Geologic Factors Pertinent To The Proposed A. J. Wiley
Hydroelectric Project, No. 2845, Bliss, Idaho

Harold E. Malde

Open-File Report 81-569

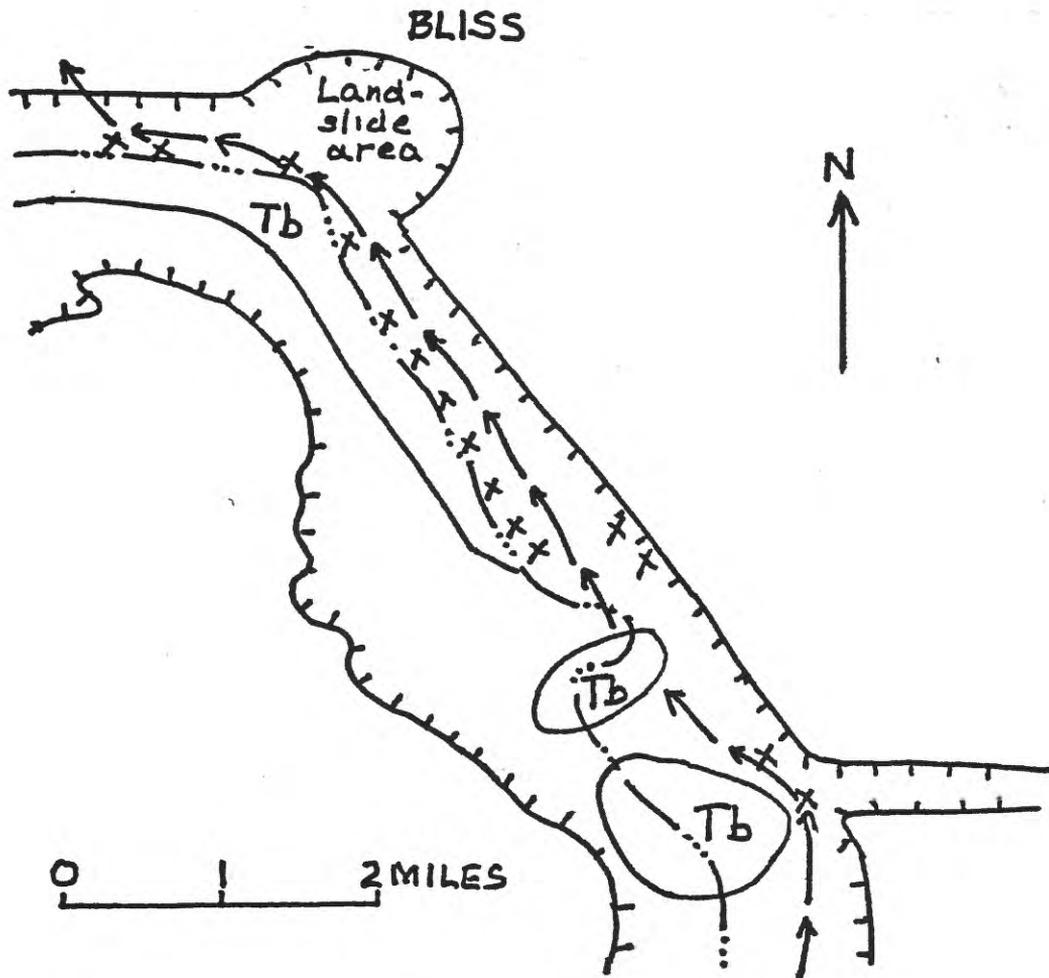
From the proposed dam site to the Bliss landslide, McKinney pillow lava is continuously exposed except for a covered interval from 0.3 to 0.7 of a mile above the dam. The covered interval is at the foot of a segment of the canyon wall that closely corresponds with the right wall of the former canyon, judging from a remnant of Madson Basalt below the canyon rim. Because Banbury Basalt along the left wall is exposed 500 feet south of the river, the floor of the former canyon must lie approximately beneath the river. The depth of the former canyon in the right abutment of the proposed dam (altitude 2,550 feet) indicates that the canyon floor can be expected to be about 100 feet below the

river at this place, covered by a substantial thickness of pillow lava. Drilling to test this inference would be desirable because of the connection that might be thereby confirmed with pillow lava farther upstream. Such a connection would augment the length of the reservoir where water could be carried to the right abutment via the concealed canyon fill of pillow lava. Also, if such a connection is confirmed, the task of installing an impervious blanket to prevent leakage from the proposed reservoir into the pillow lava--assuming that no other remedy is more practical--would be greatly increased. The length to be sealed would reach at least a mile upstream, and an undetermined amount of river gravel might have to be removed from the reservoir floor before a sealant could be effectively applied.

Figure 9.--Section through the proposed earth-fill embankment
(from Exhibit L submitted by the applicant).

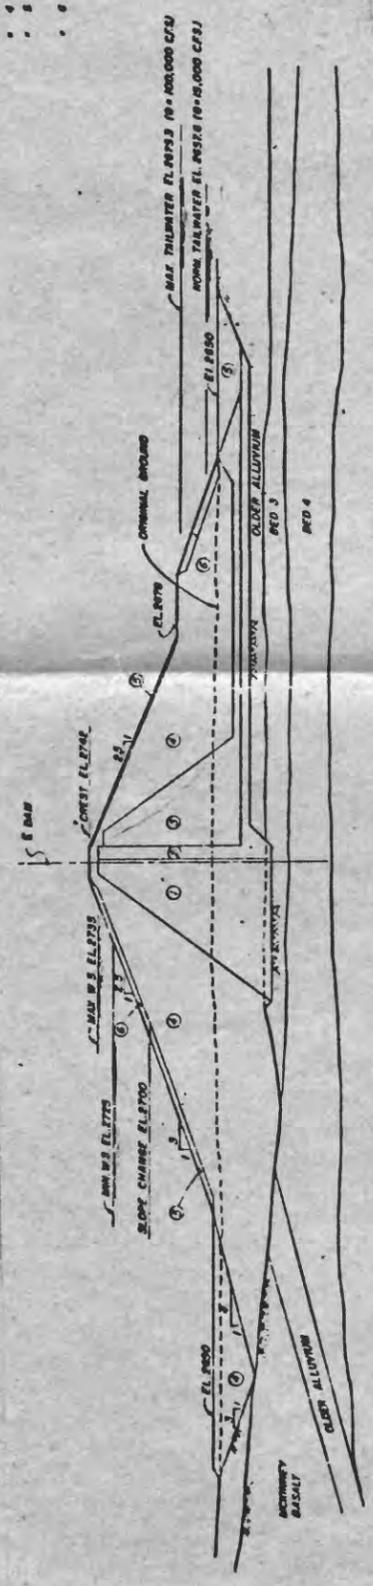
The design criteria for the earth-fill embankment focus on the control of seepage in the section downstream from the core. Thus, the applicant mentions that joints and fractures in Banbury Basalt at the left abutment will be sealed with gunite and that the surface of McKinney pillow lava in the right abutment will be similarly sealed. The plans further call for grouting under the spillway section. The applicant has also considered seepage through bed 4, a unit of sand grading upward to silt that forms a horizontal stratum as much as 47 feet thick under the proposed dam (figs. 3 and 9). It is recognized that the transmissivity of bed 4 must be determined in order to design a relief well system. The purpose of these various methods for controlling seepage is to achieve suitable tailwater hydrostatic conditions in the embankment section, such that water leaking from the dam will be discharged below river level rather than through the exposed face of the dam. My discussion of the present plans for control of seepage is limited to features of the McKinney pillow lava and to bed 4.

On the other hand, piping in bed 4 might be inhibited by an overlying layer of clay, bed 3. Bed 3, however, is only a few feet thick, and its distribution in the area of the earth-fill embankment is poorly determined by drilling. Thus, it is possible that bed 3 is not continuously present in the area under the core of the dam, as represented in figure 9. If bed 3 proves to be missing, or if it can be shown to be inadequate as an inhibitor of piping under the embankment section, another impermeable cap may be needed to protect the core from water that could percolate upward from bed 4.

Plans by the applicant call for placement of "transition-drain filter material" directly on the debris (older alluvium) in the downstream part of the embankment section (zone 2 in fig. 9). In other words, the debris would be kept continuously wet by seepage through the drain material. The debris might thereby become saturated and lose its strength, thus causing failure of the dam. To evaluate the potential loss of strength in the debris, I am advised by R. W. Fleming of the U.S. Geological Survey, that

appropriate tests should be made to determine its behavior when wet. Based on these determinations, a stability analysis through the embankment would provide an estimate of predicted stability. For the intake and spillway sections, a similar analysis is needed, together with an evaluation of the potential for differential settling. Unequal subsidence could be caused by differences in consolidation characteristics of the debris and the pillow lava. Depending on the tests and the findings about the lithologic variability of the debris under the proposed structure, the wise course might be to completely excavate the debris from the area of the dam site.

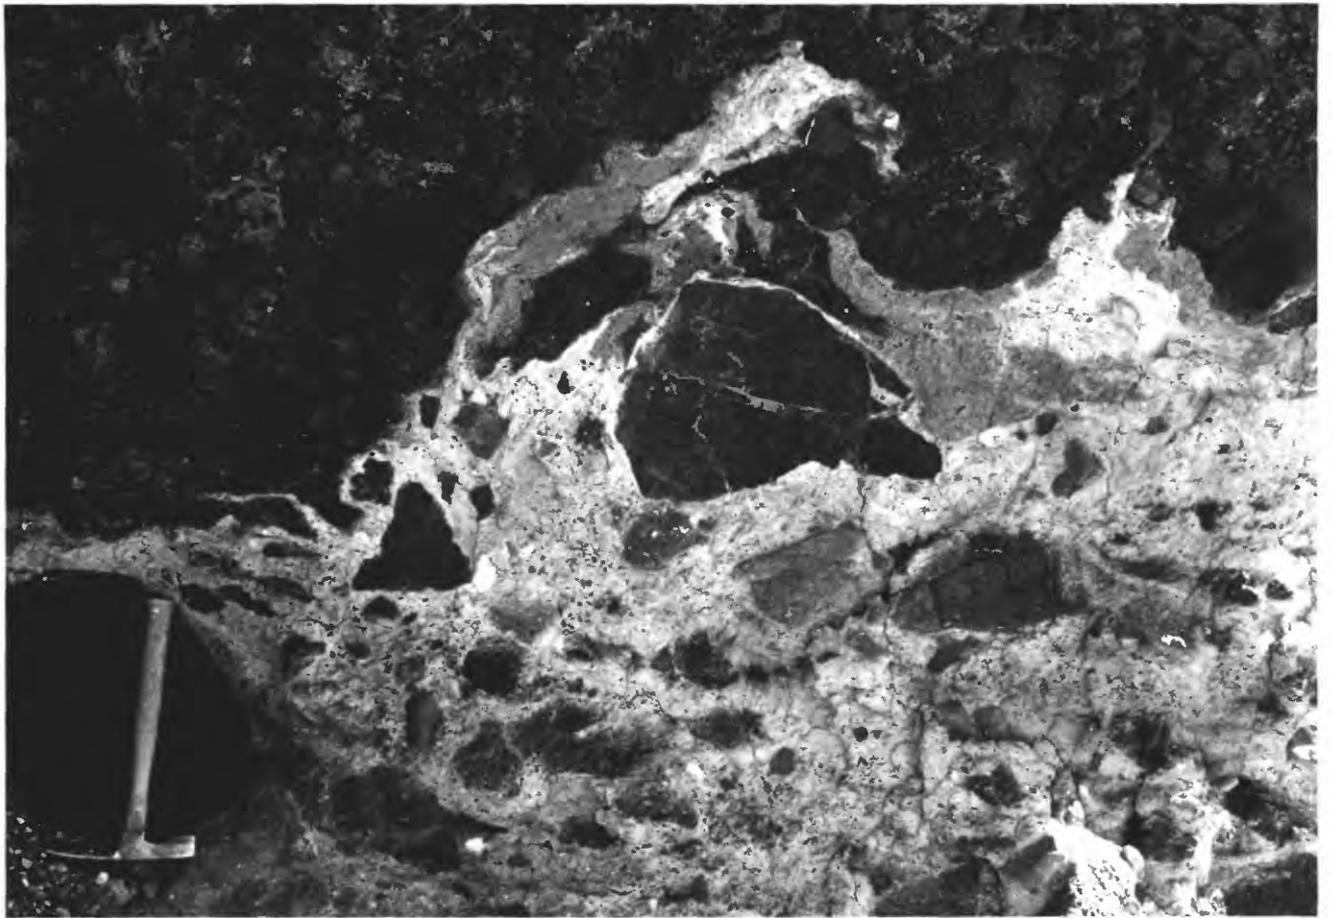
The presence of the debris at the proposed dam site poses difficult problems in engineering (see Deficiency L/N-2). Its physical characteristics must be explored with the knowledge that significant lithologic changes can be expected in distances as short as a few feet. Its hydraulic conductivity will likely vary in accord with changes in the mixture of basaltic fragments and matrix, and in accord with gradational relations to McKinney pillow lava. Finally, the debris appears to be susceptible to a loss in strength when wet.

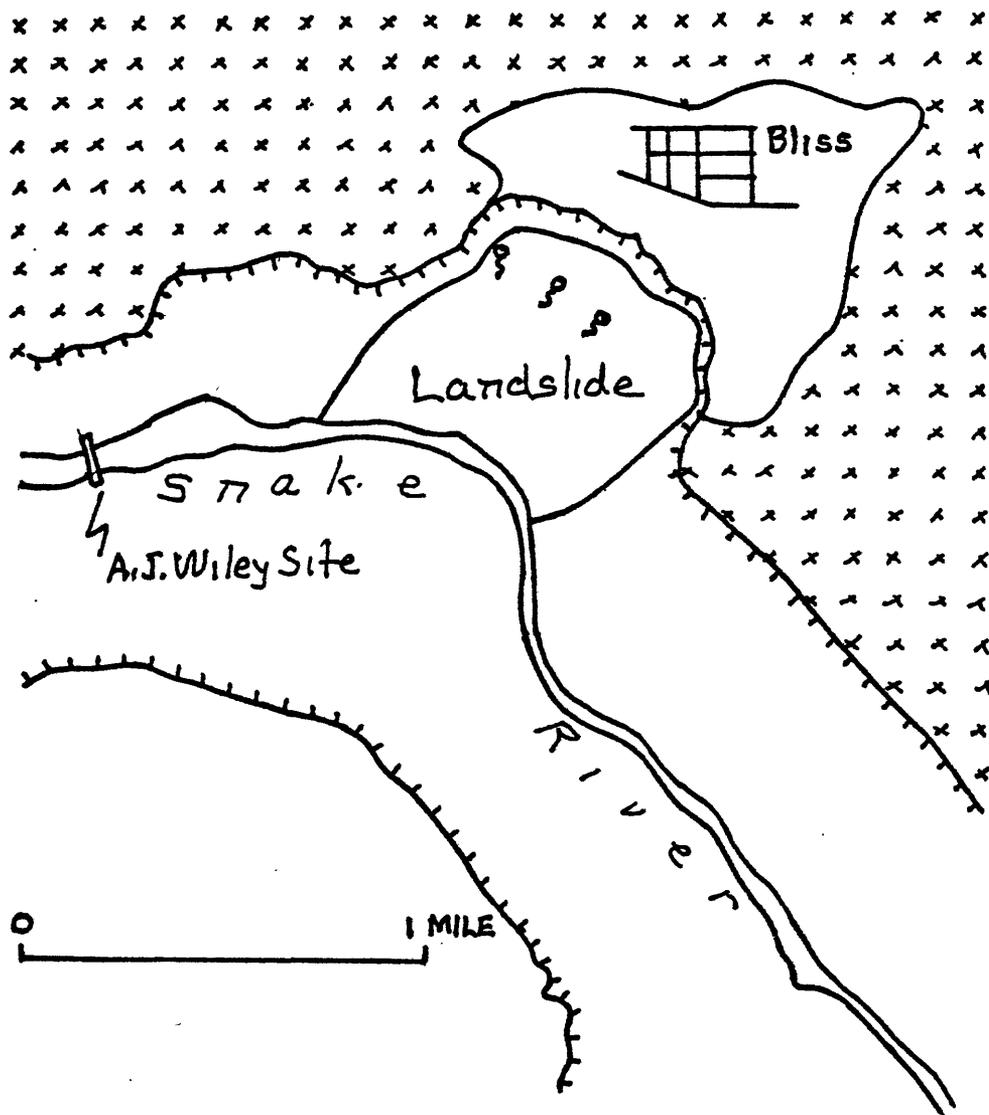
Current movement in the upper part of the Bliss landslide may be induced in part by water that seeps out in the slide area below Bliss at an altitude of 3,000 feet (fig. 14). The seeps are along the trend of the scarp mentioned above. Water usually contributes to the movement of landslides by increasing shear stress (the added weight of the water) and by reducing shear strength (decreased intergranular friction, softening, and the like). It is common knowledge in the area that discharge from the seeps has increased with growing use of septic tanks at Bliss, and

The applicant's present understanding of the Bliss landslide is based only on geologic mapping, although "drilling and testing is planned . . . to assure continued resistance of the hillside to large scale failure" (letter of Carter B. King to Ralph I. Clements, March 17, 1980). The geologic problem presented by the Bliss landslide is not whether it is indeed resisting failure, but whether the landslide will fail during the life of the A. J. Wiley Hydroelectric Project, whether failures can be expected to be caused by the project, and whether failures represent a potential risk to the project itself.

Figure 15.--Representative profile of the Bliss landslide showing two hypothetical positions of concealed Banbury Basalt: A, close to the front of the slide; and B, deeply buried by the upper part. The vertical scale is exaggerated by a factor of two.

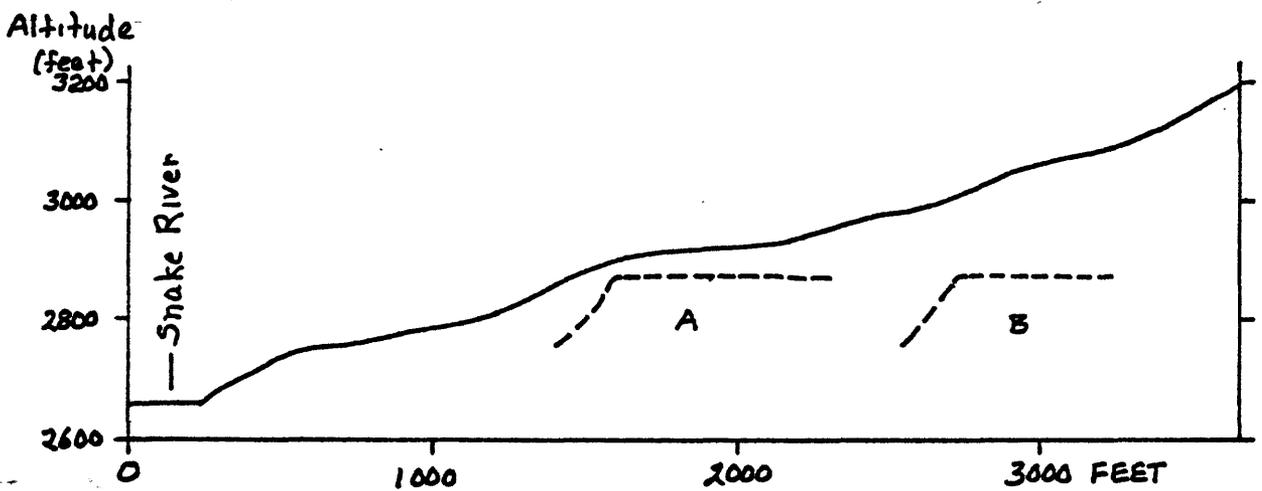
Of particular concern in the upper part of the landslide is the position of the Banbury Basalt, which underlies the Glens Ferry Formation. If the concealed Banbury is relatively near the front of the slide, at position A in figure 15, it can be expected to increase the stability of the upper part of the landslide--at least in the sense of providing a relatively resistant buttress to movements that may begin at a higher level. On the other hand, if the Banbury is deeply buried by the upper part of the landslide, lying at position B in figure 15, or if it is below the reach of existing slippage surfaces, it would provide little or no resistance. In this circumstance, movements in the upper part of the slide might be propagated to the lower part. An even greater potential danger is that calving at the reservoir might advance upward to the head of the landslide, perhaps leading to enlargement of the slide by headward retreat.

Elsewhere along the canyon of the Snake River, some large landslides in the Glens Ferry Formation seem to have formed by sudden failure of massive sections of the canyon wall, thus producing widespread sheets of debris in lowland areas. Good examples may be seen in a landslide that covers about 2 1/2 square miles in an area 2-3 miles northwest of King Hill and on the north side of the canyon at the head of Indian Cove. Therefore, large-scale instantaneous collapse of the Bliss landslide is possible, even though large slides of more or less coherent masses are more generally to be expected primarily in indurated rocks (Müller, 1968). Because of the potential hazard, it would be prudent to evaluate the likelihood of widespread failure of the Bliss landslide by making a complete stability analysis. Sudden large-scale collapse of the landslide could displace a substantial part of the proposed reservoir. In this event, the displaced water almost surely would overtop the dam.
